COVER SHEET
C0.0
1 of 53 Sheets

EAST TOWN CROSSING PHASE 1

STORM DRAINAGE PLAN NE

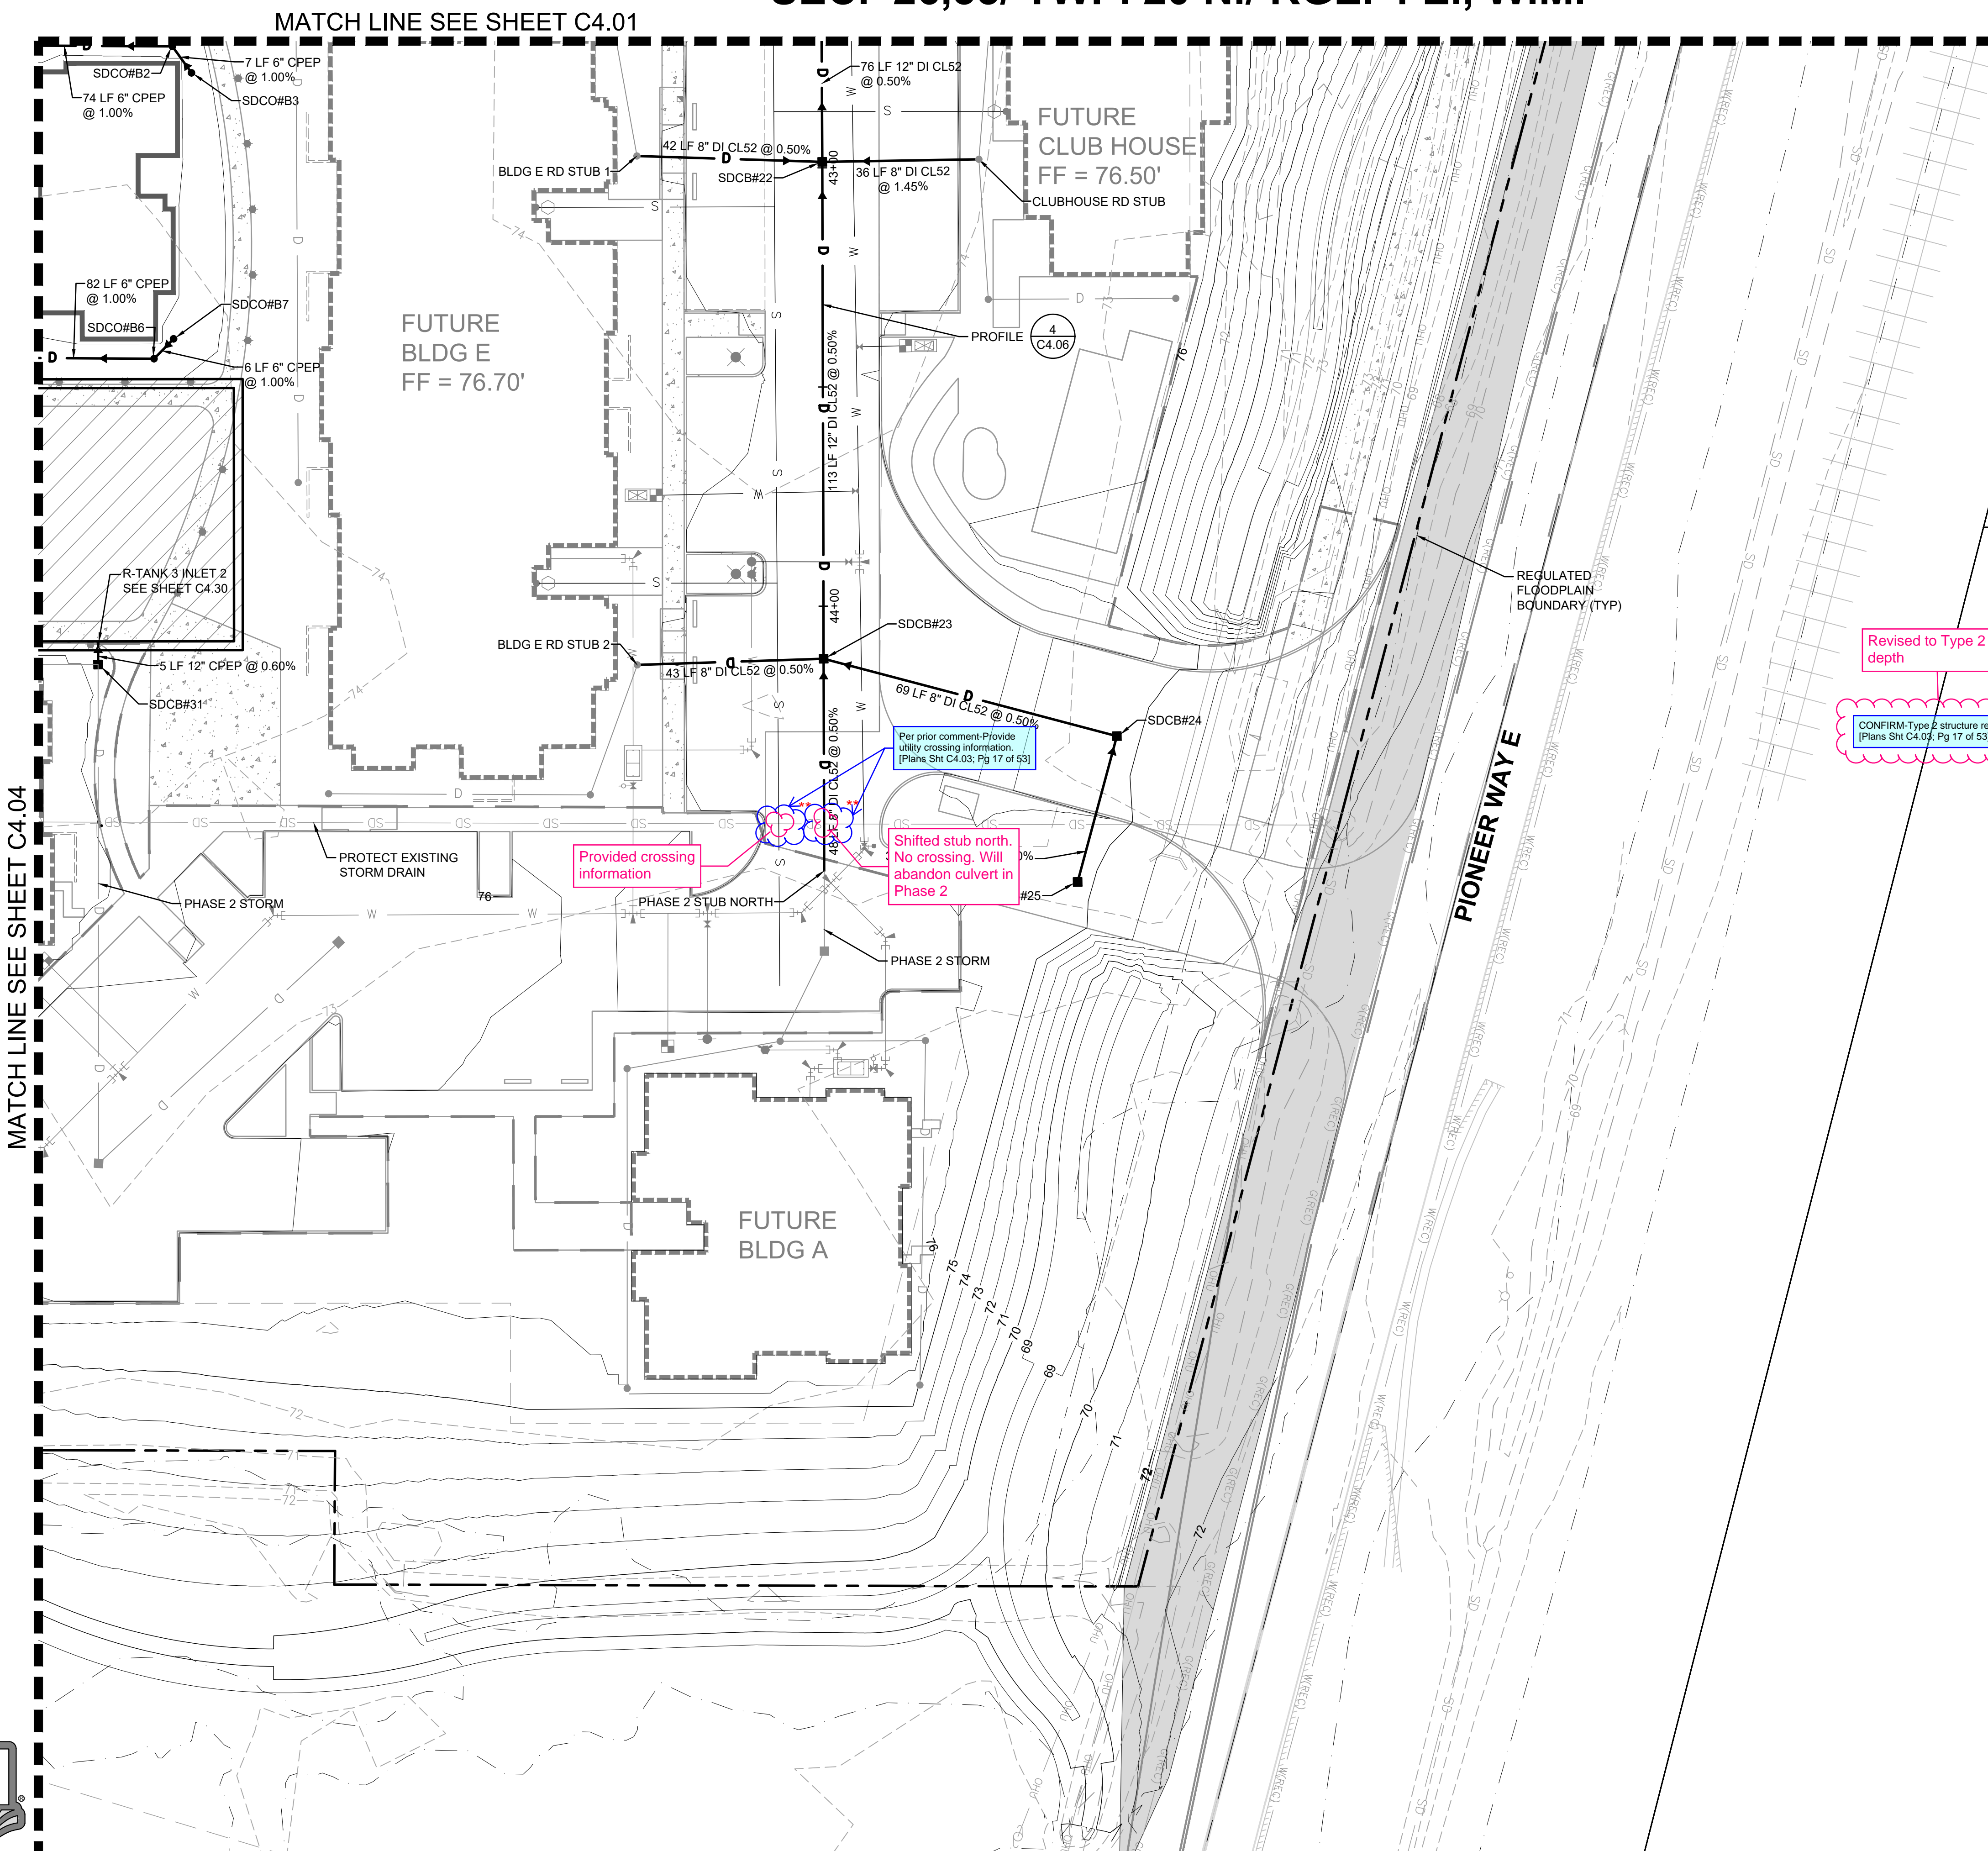
Revised to Type 2 for depth
CONFIRM Type 2 structure req'd. [Plans Sht C4.03, Pg 17 of 53]

Sheet Title:
STORM DRAINAGE PLAN SE

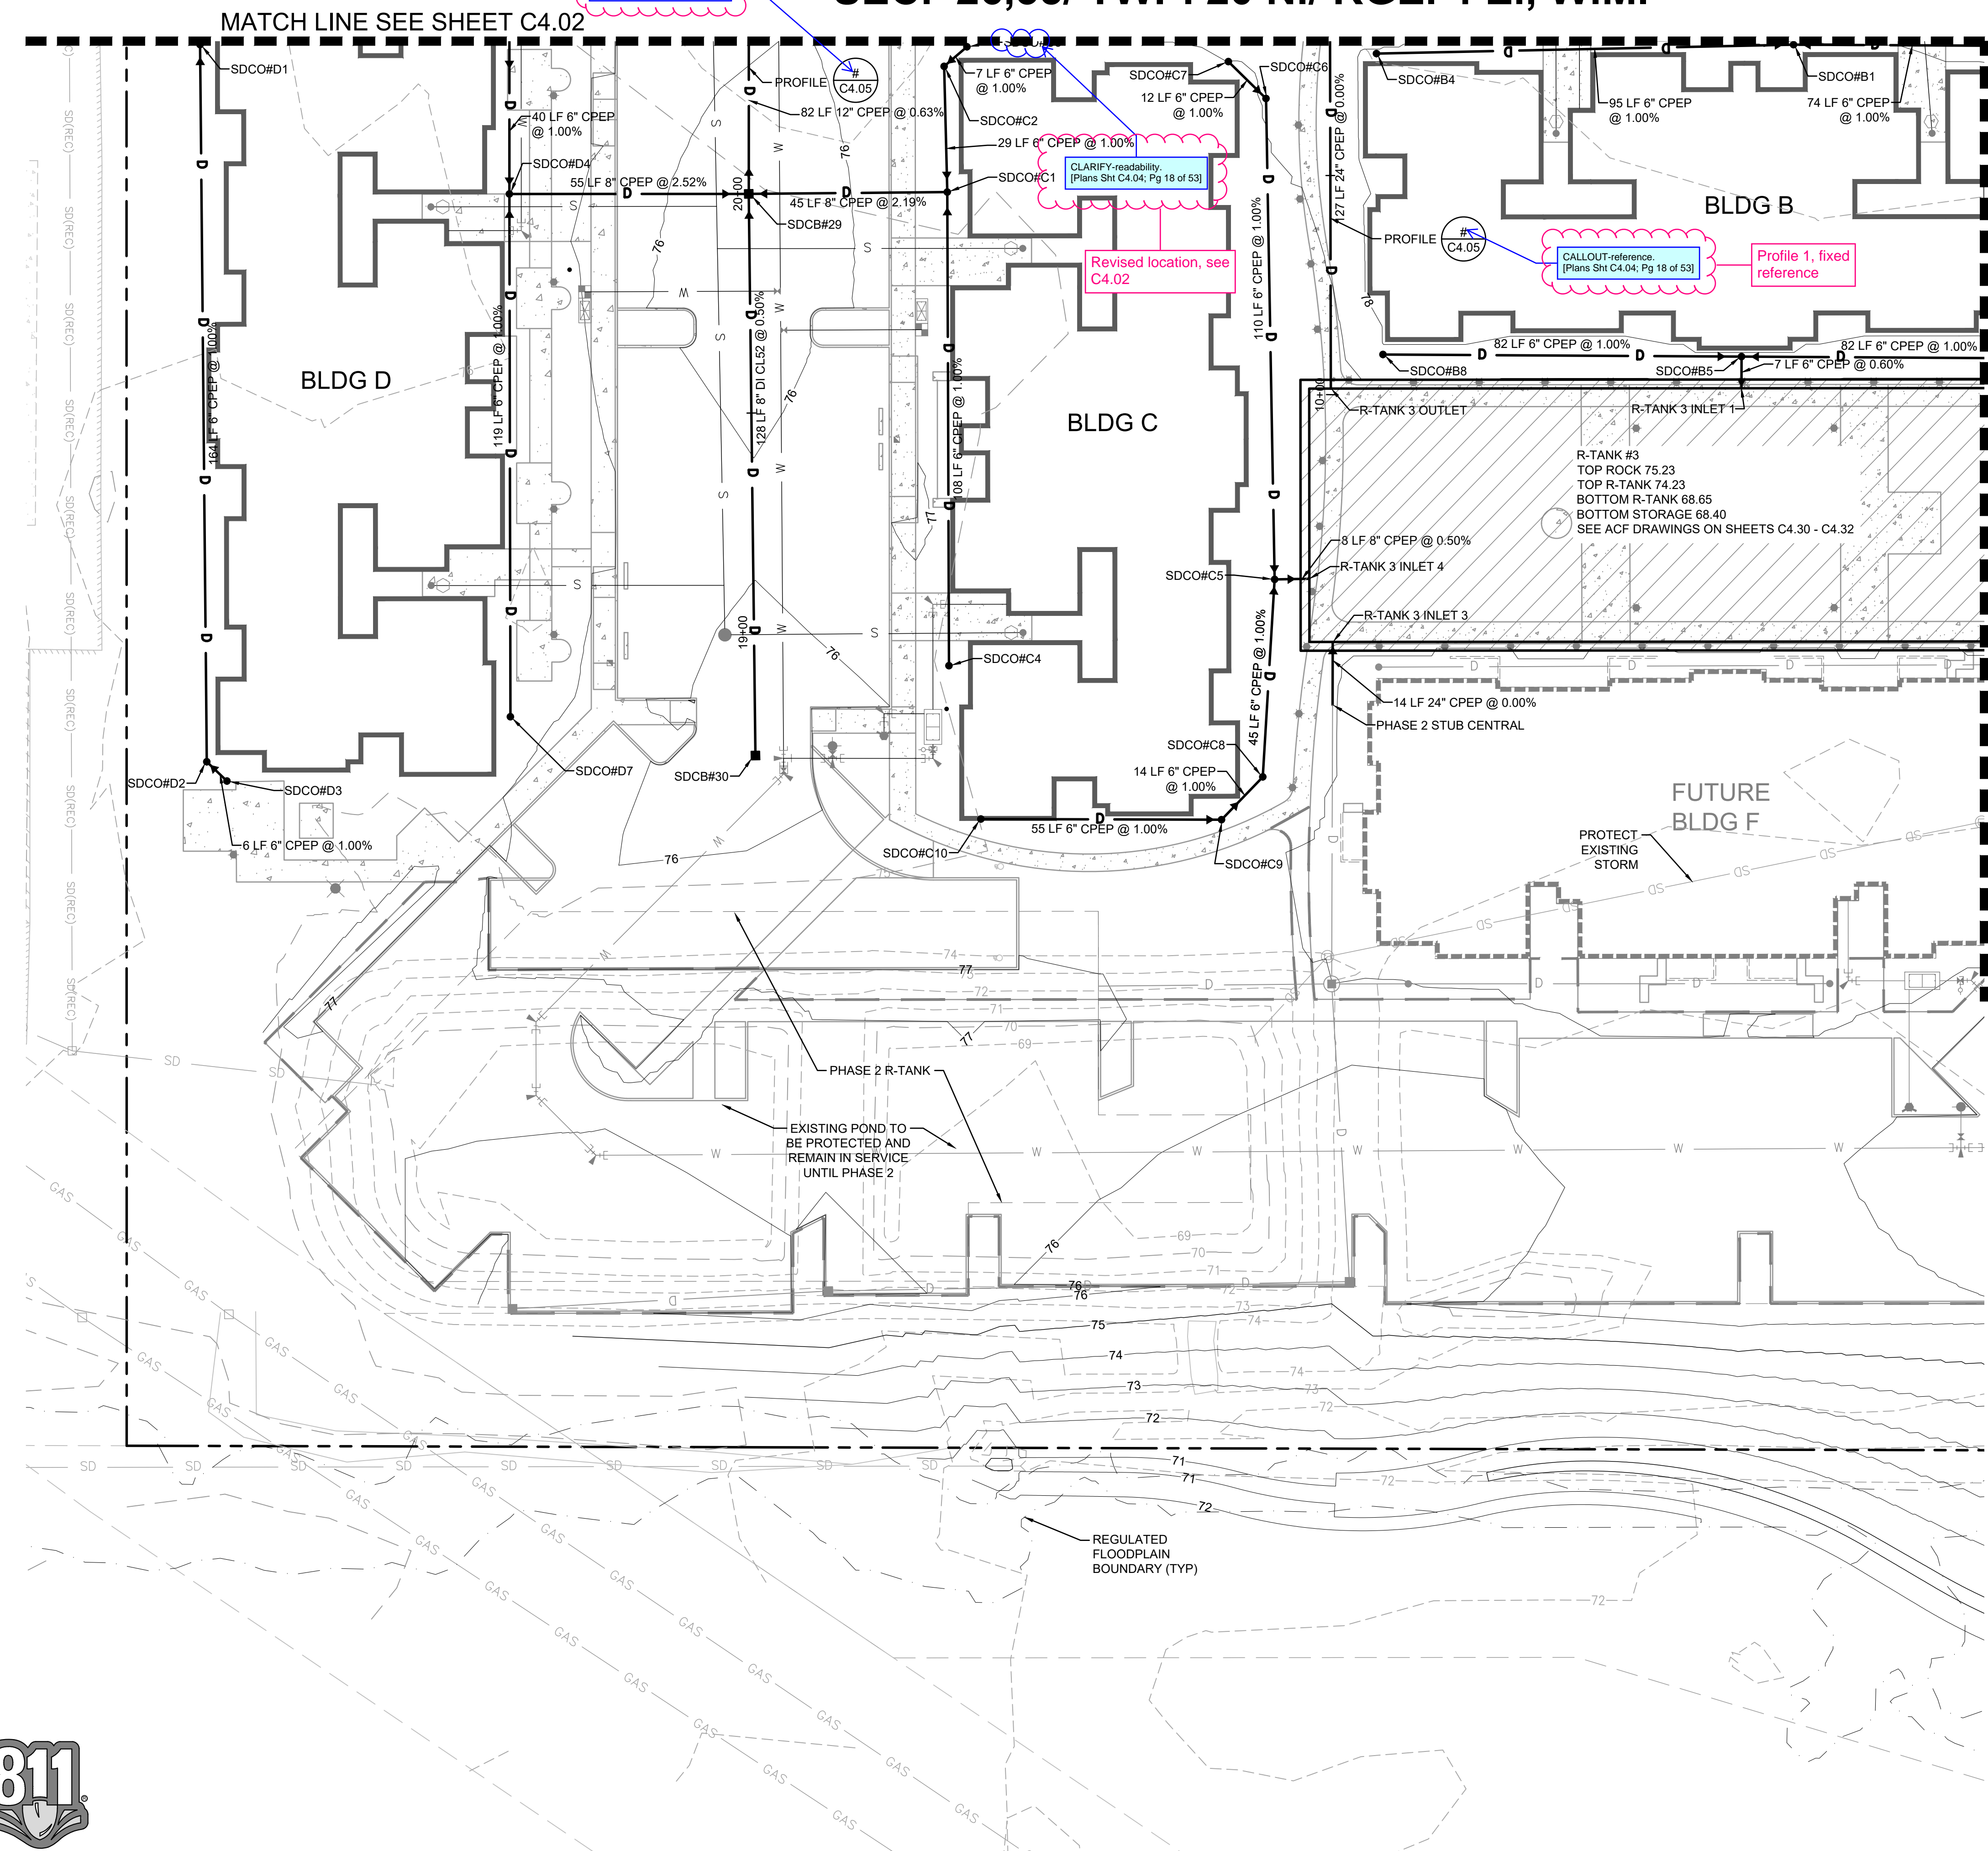
PVI: structure not shown on this sheet. Callout on Sht C4.02. (Plans Sht C4.04, Pg 18 of 53)

CALLOUT-reference. (Plans Sht C4.04; Pg 18 of 53)

CLARIFY-readability. (Plans Sht C4.04; Pg 18 of 53)

CALLOUT-reference. (Plans Sht C4.04; Pg 18 of 53)

Profile 2, fixed reference

Revised location, see C4.02
